ORIGINATION FORM

Proposed Revisions to a Standard Plans Index
(Please provide all information — Incomplete forms will be returned)

Index Number: 455-112

Index Title: 12" CFRP & SS Prestressed Concrete Piles

SECTION A-A

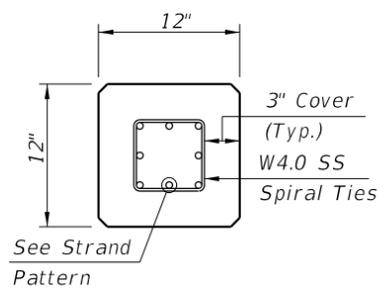
Added 0.6" HSSS strand

STRAND PATTERN
 8 ~ 1/2" Ø, HSSS at 24 kips
8~0.6" Ø HSSS at 26 kips
